Groundwater Application Review Summary Form

Application # LL- 1924

GW Reviewer James Hootsmans/Josh Hackett Date Review Completed: 1/25/2023

PUBLIC INTEREST REVIEW FOR GROUNDWATER APPLICATIONS

Well Location Map

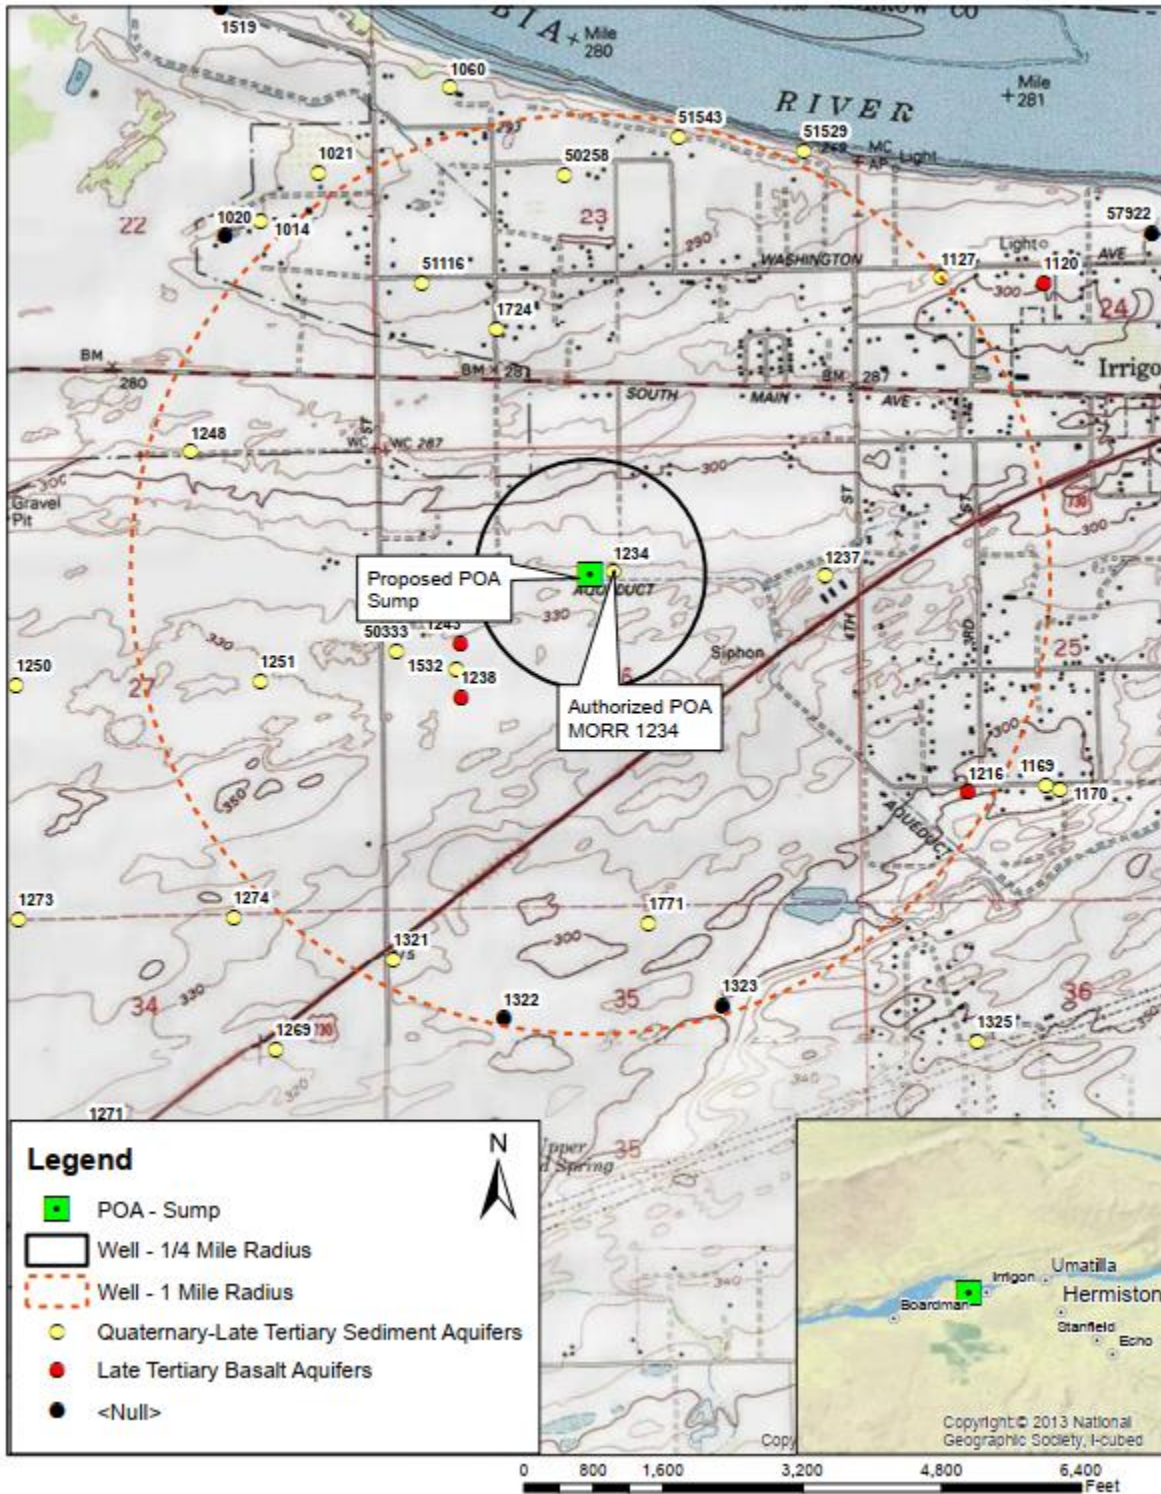
A4. **Comments:** The proposed POA is ~1 mile south of the Columbia River and ~1.3 miles southwest of Irrigon, Oregon (See Site Map).

The proposed POA is a sump 270 feet west of an existing irrigation well, MORR 1234. As per by OAR 690-200-0050 (103), a "sump" means a hole dug to a depth of ten feet or less with a diameter greater than ten feet in which groundwater is sought or encountered. MORR 1234 develops water within a sand and gravel unconfined aquifer. The well is within the Ordinance Basalt Critical Groundwater Area, so a permit for a gravel well is possible. Therefore, the proposed POA would develop water within the surficial sediments of the sand and gravel alluvium.
